SUPPORT NOTE

SN-101

Tightening Sun EC1.3W Handles

#4 Nuts (25 plcs)

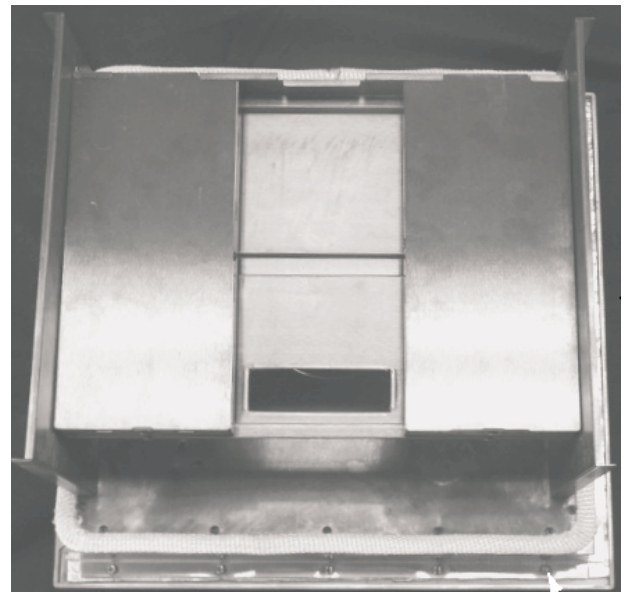
Over time the Sun EC1.3W oven door handles can work loose. This support note provides directions for remedying the problem. These repairs should not be attempted while the oven door is still at elevated temperatures. All new Sun EC1.3W oven doors shipped after September 2001, have the change already incorporated

1. All of the #4 nuts and lock washers around the outside edge need to be removed so that the inside of the door can be lifted away from the front. In addition, the fiberglass rope needs to be removed from the purge hole so that friction on the high temperature cable does not hinder lifting. Note: There is no need to remove the load boxes or the brackets (internal or external) in order to tighten the handles.

2. After lifting the inside of the door away, it is shifted as needed to gain access to the beveled screws that hold the handles in place from the inside of the door.

3. One beveled screw should be replaced at a time with a #8-32 x 5/8" screw, #8 split lock washer, and #10 flat washer. Otherwise, alignment is easily lost and the repair is much more difficult.
